**CITY OF MANNINGTON  
MARION COUNTY, WEST VIRGINIA  
CITY OF MANNINGTON MUNICIPAL POOL**

**ADDENDUM #2**

**JUNE 20, 2023**

**THRASHER PROJECT #010-10191**

**A3.01R**

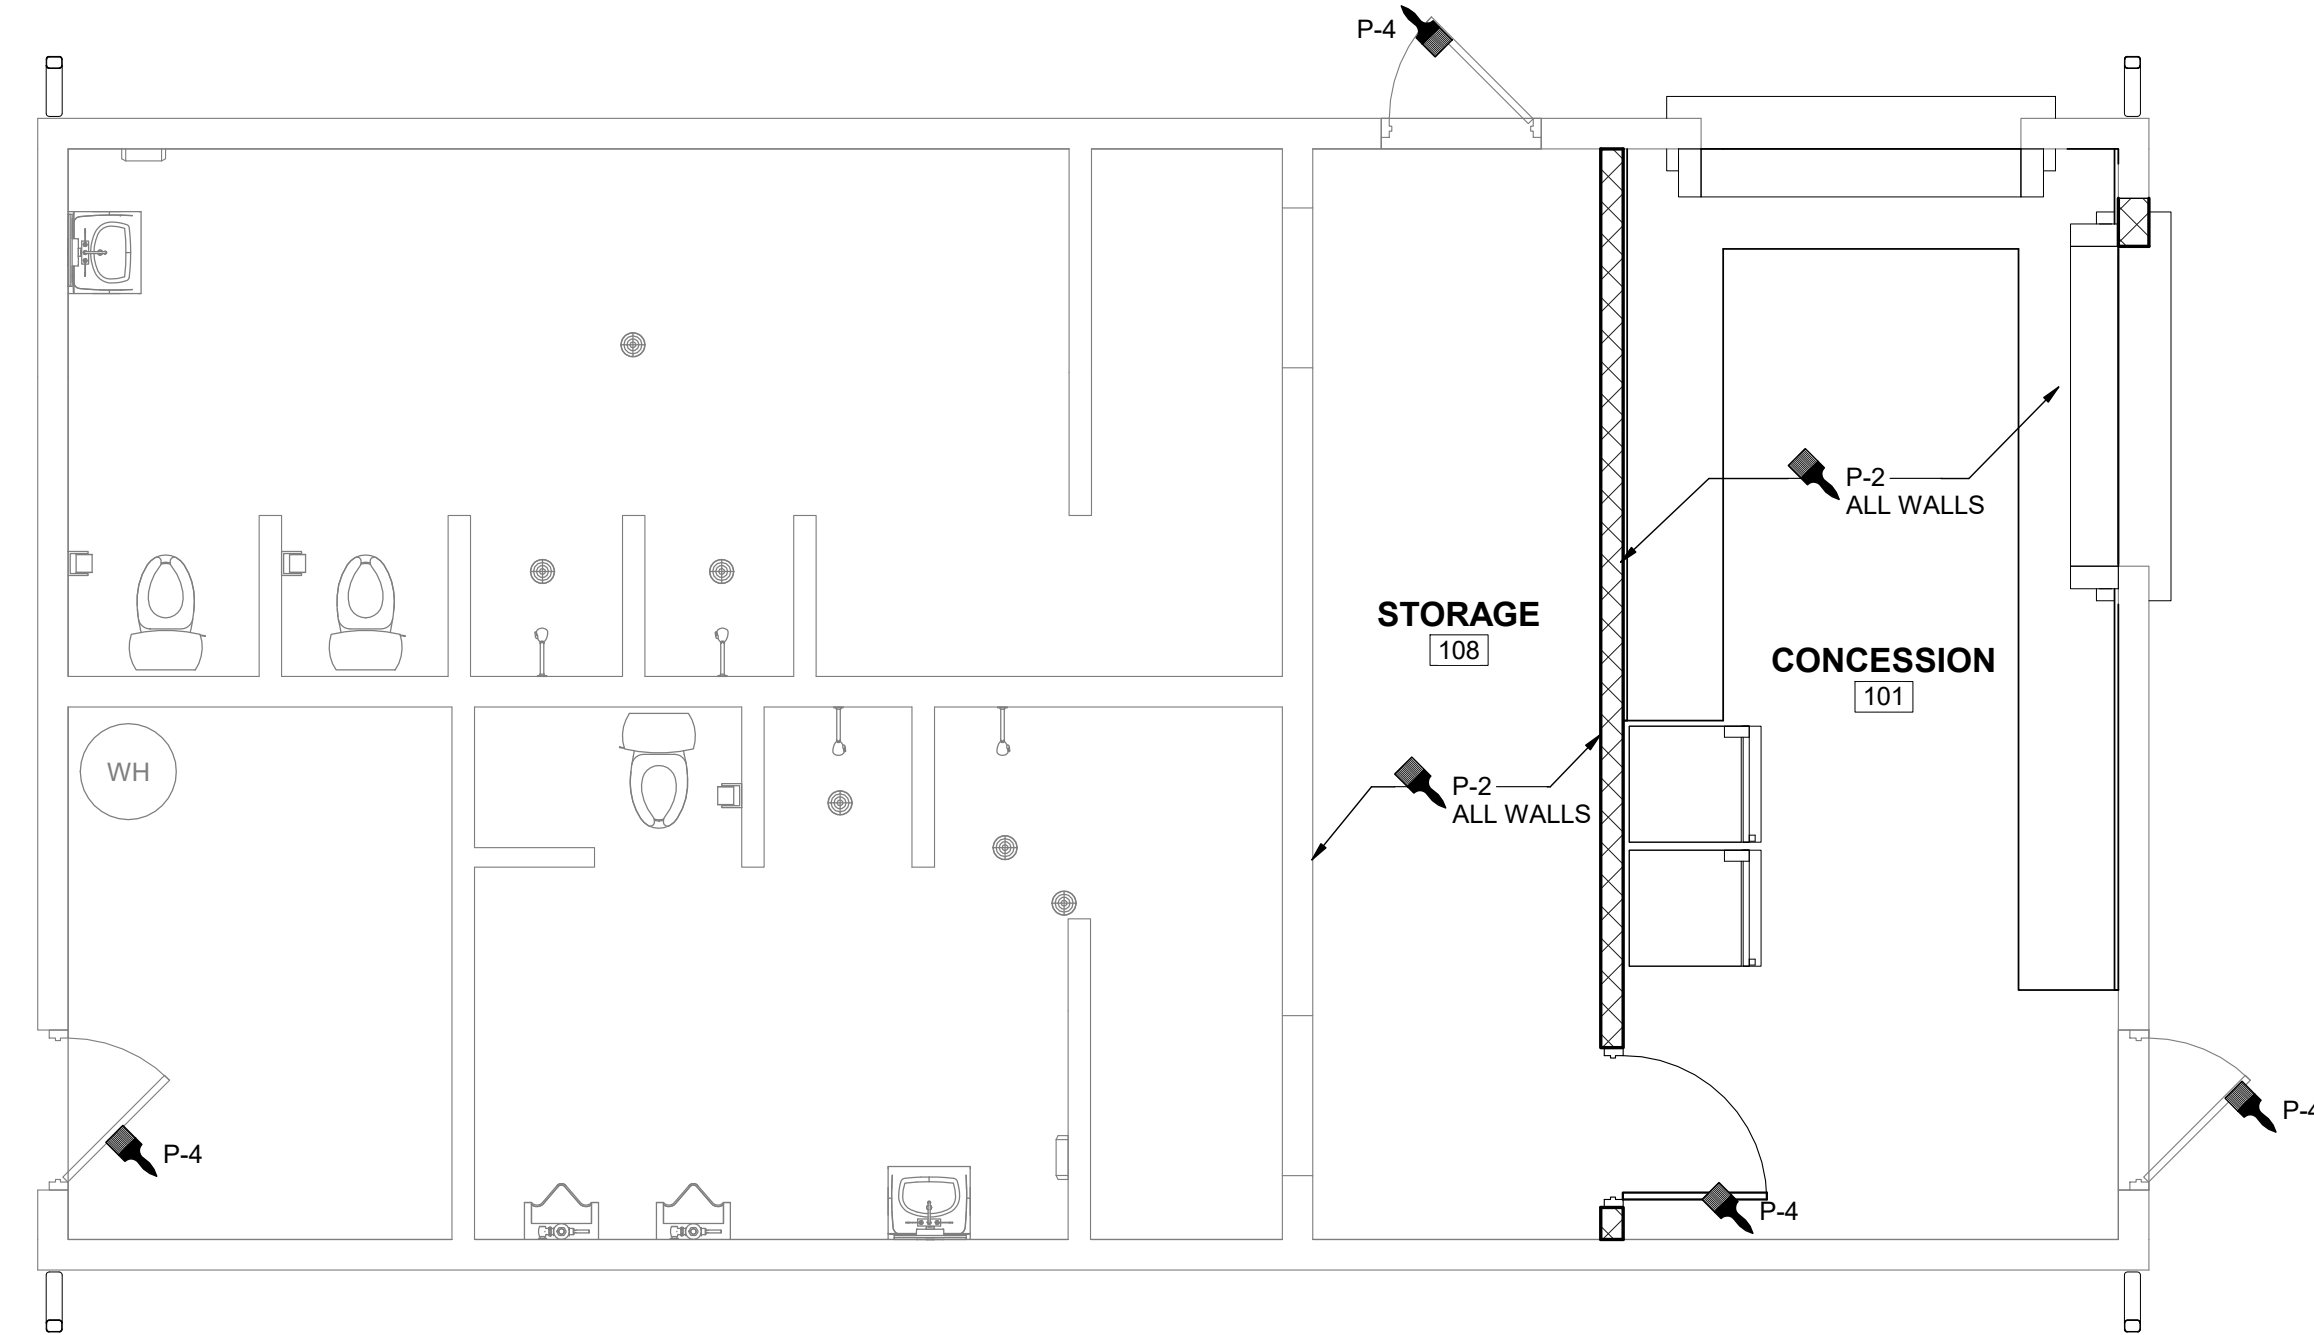
Is seamless aluminum gutter with aluminum downspout acceptable in-place of the requested metal gutter shown on dwg. A3.01?

*The existing gutter is to remain in place.*
